**Cub Crafters, Inc. Considers Compliance Mandatory**

**SUBJECT:** UN-COMMANDED FLAP RETRACTION

**MODELS AFFECTED:** CC11-100 S/N00002 thru S/N00031

**Figure 1**

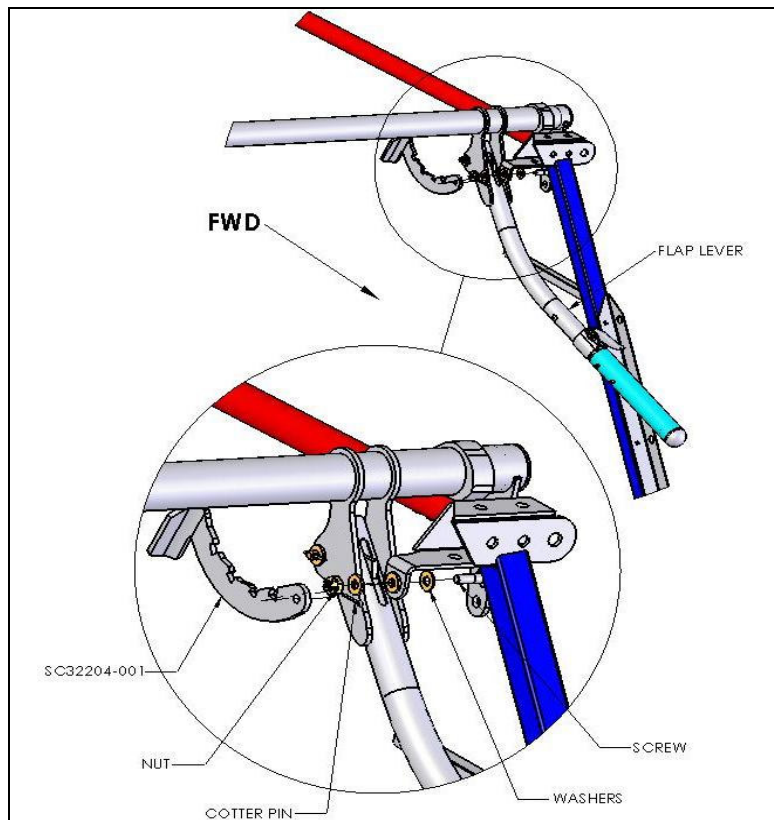
1. Remove existing SC32204-001 by removing hardware as shown in Figure 1. Retain hardware and discard SC32204-001 and cotter pin.
2. Rotate flap lever arm fore and aft while applying pressure inboard or outboard to center and align flap cross bar with fuselage centerline as necessary.
3. Install SC32204-001 Revision F using same hardware and new cotter pin (AN380-2-2). SC32204-001 should be centered thru flap lever slot (see Figure 2). Additional washers (AN960-10 or AN960-10L) may be used to shim SC32204-001 to achieve center position. Do not use more than 4 washers per side to shim.

**Figure 2**

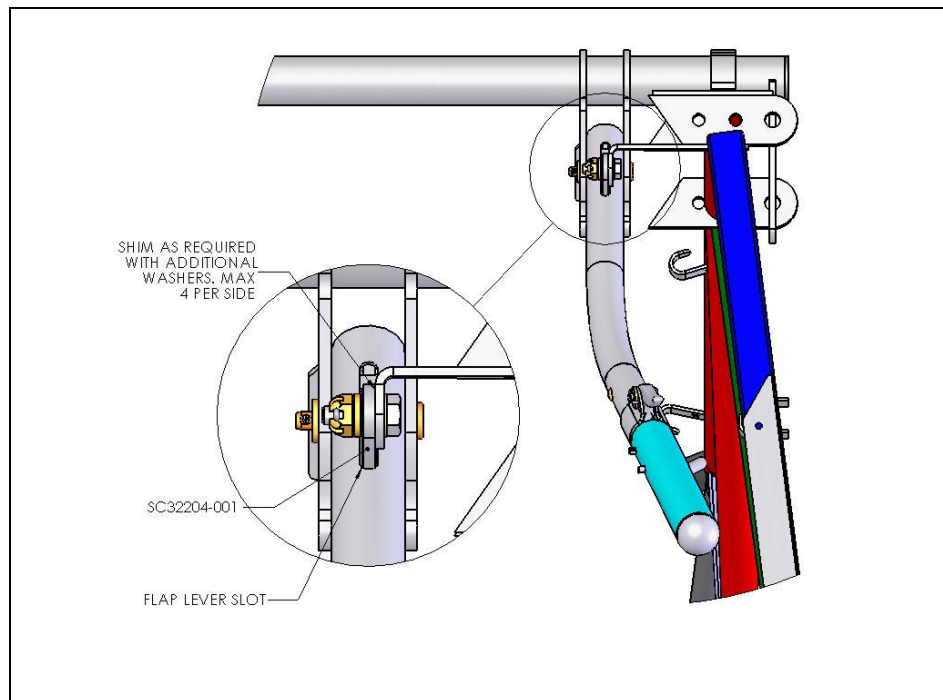
4. Ensure flaps work properly and all positions lock. Ensure no interference is occurring between flap lever and fuselage or any other components.
  5. Make logbook entry "Service Bulletin SB00005 complied with".
- If any discrepancies found, Contact Cub Crafters, Inc. prior to next flight.
